EEE Modifications

P802.3bj comments 115, 116, 117

*P802.3bm – describe fast-wake signaling
compatible with OTN mapper*

Steve Trowbridge

Figure 78-3—Overview of EEE LPI operation

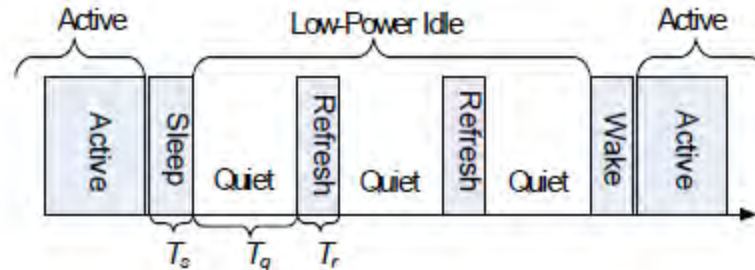
- With “Fast Wake”, there is no Quiet period since the transmitter is left on. Refresh is implicit since the transmitter is not disabled. There is no “Sleep” signal needed as the transmitter will never go quiet. T_s , T_q , T_r are all irrelevant

Figure 78-7-Overview of Fast Wake Operation

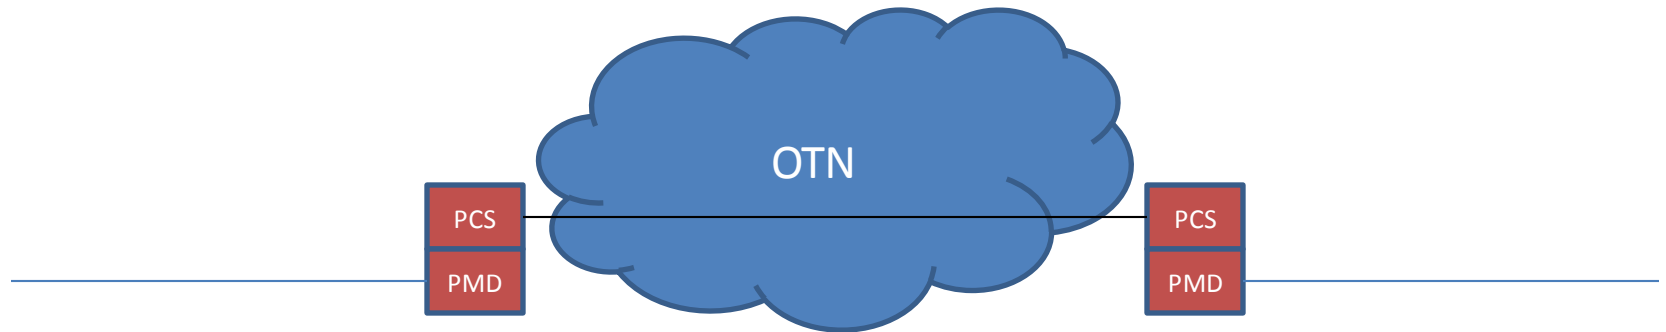
- Note that Rapid Alignment Markers are needed for the “Refresh” and “Wake” steps of the “Deep Sleep” process of Figure 78-3. They are not needed at all for the process of Figure 78-7 which can tell that the link is up without “refresh”, and can switch from active to fast-wake signaling without the warning needed if the Tx were to be disabled.
